CITY OF ALBUQUERQUE

Re: O'Reilly Auto Parts
6830 Coors Blvd NW
Request for Certificate of Occupancy
Transportation Development Final Inspection
Engineer's/Architect's Stamp dated 5-20-19 (E12D006G)
Certification dated 5-20-19

SITE PLAN CERTIFICATION

Site Plan for Building Permit

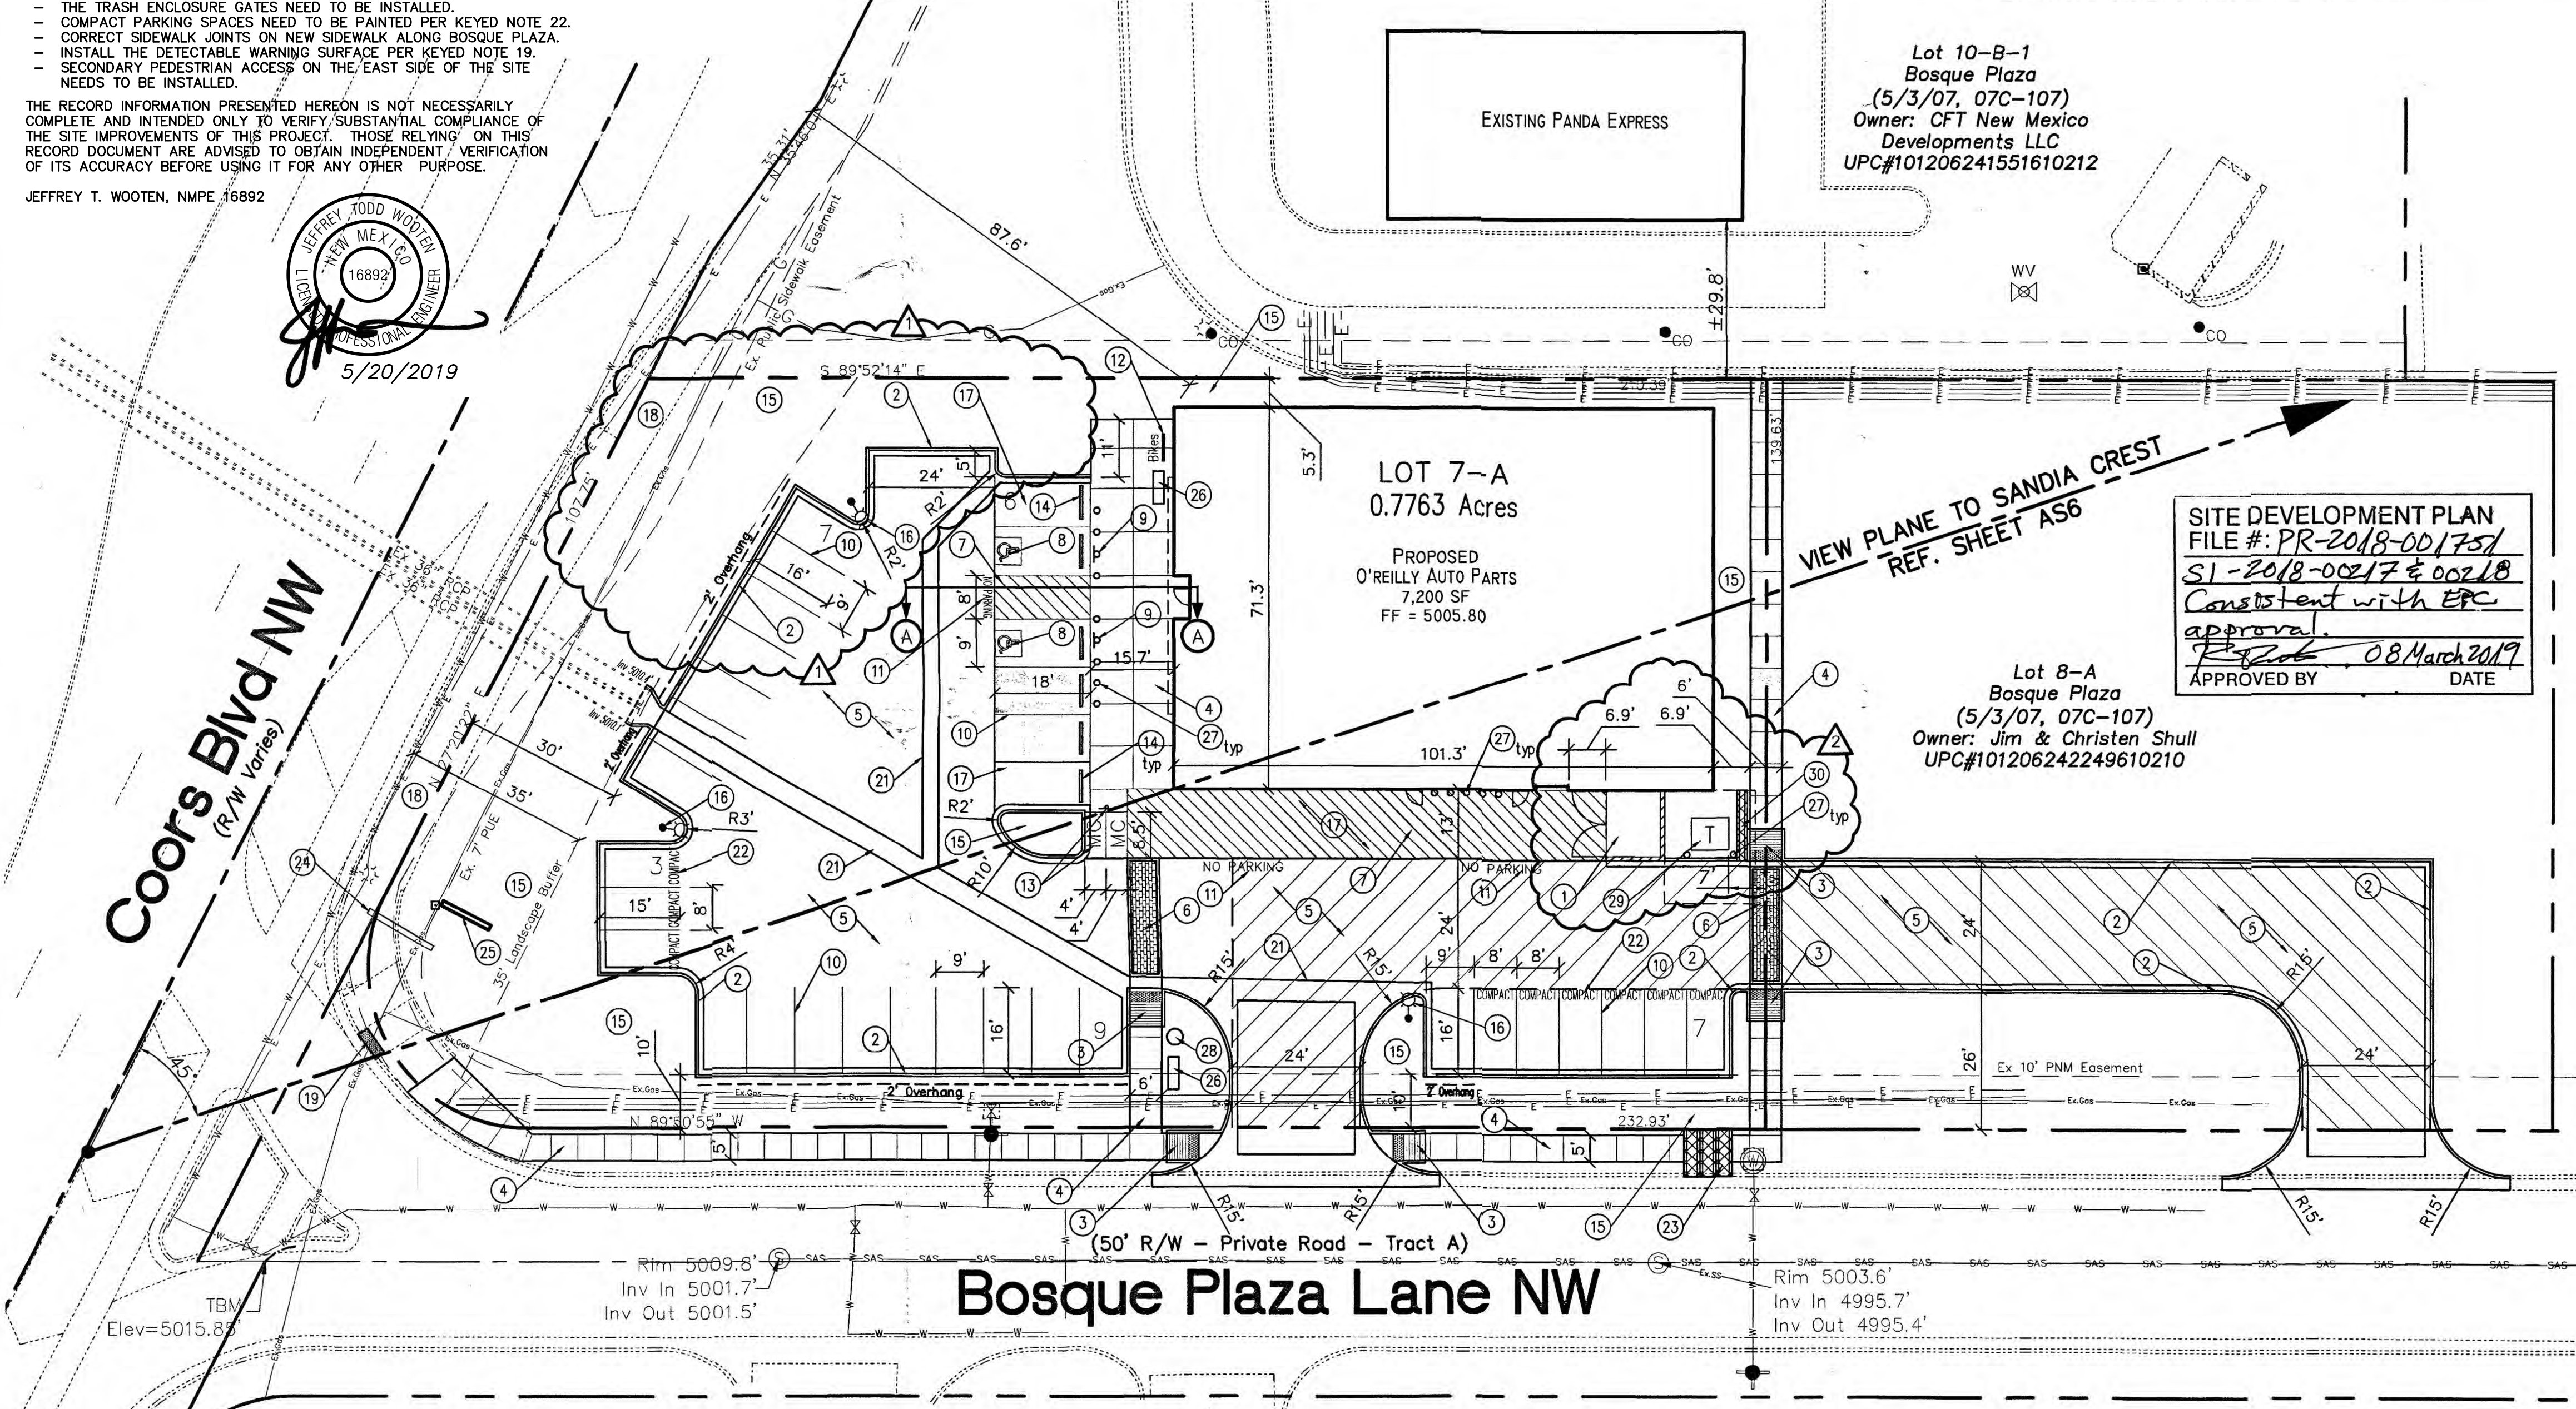
- THE FOLLOWING ITEMS NEED TO BE CORRECTED PRIOR TO PERMANENT CO:
- ADA ROUTE SIDEWALK TO BOSQUE PLAZA SHOULD BE CORRECTED TO A 5% MAX RUNNING SLOPE (OR 8% WITH HANDRAILS).
 - THE BENCH, TRASH CAN, AND TREE SHOULD BE ADDED ADJACENT TO THE ADA SIDEWALK TO BOSQUE PLAZA.
 - THE LIGHT POLES EXCEED THE MAXIMUM 16' HEIGHT PER THE APPROVED SITE PLAN FOR SUBDIVISION. THE CORRECT POLES MUST BE INSTALLED.
 - THE TRASH ENCLOSURE GATES NEED TO BE INSTALLED.
 - COMPACT PARKING SPACES NEED TO BE PAINTED PER KEYED NOTE 22.
 - CORRECT SIDEWALK JOINTS ON NEW SIDEWALK ALONG BOSQUE PLAZA.
 - INSTALL THE DETECTABLE WARNING SURFACE PER KEYED NOTE 19.
 - SECONDARY PEDESTRIAN ACCESS ON THE EAST SIDE OF THE SITE NEEDS TO BE INSTALLED.
